Defective phenomenon:

L3 crack

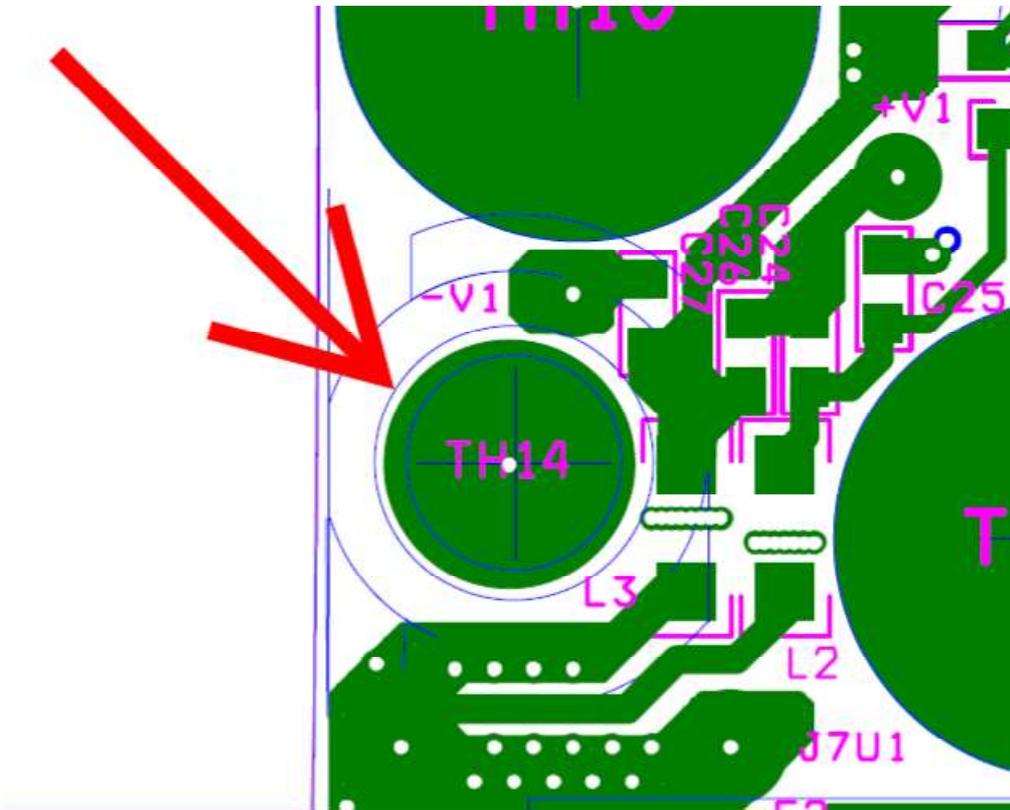
1. We were using the strength much much more than the ones which users may apply for fuse replacement to push PCB module several times for three units.
2. We then use microscope to check their L3 & L2 but did not find their solders were with any crack clue.
3. We then disconnected the wire indicated by blue line below and repeated above tests again. Then we found one unit is with crack sign.

1. We think L3 crack problem should not be from fuse replacement. It is because the wire, connecting main PCB module and terminal PCB module, limits the deformation of main PCB module during fuse replacement.
2. Our Production Procedures are:
  - 2.1 To assemble main PCB module to case.
  - 2.2 To put fuse to main PCB module.
  - 2.3 To solder the wire connecting main PCB module and terminal PCB module.We think L3 crack could be from Production Procedure 2-2.
3. Another possible cause is "L3 was soldered to left trend". Please see the drawing below. The blue circle indicated by red line is the outer edge of lower case boss. If L3 was soldered to left trend, it may be pushed by that boss after the assembly of upper and lower cases. That could crack L3 too.

1. To change Production Procedures as followings:
  - 1.1 To assemble main PCB module to case
  - 1.2 To assemble terminal PCB module
  - 1.3 To solder connected wire before putting fuse to main PCB module
2. For semi-finished or finished units, to check if L2 & L3 are with crack sign. If yes, replace it.
3. To slightly cut that boss to avoid pushing L3 after the assembly of upper and lower cases.

1. To move L3 downward slightly.
2. To add ribs to two bottom corners of upper case to prevent deforming main PCB module too much during production or fuse replacement.
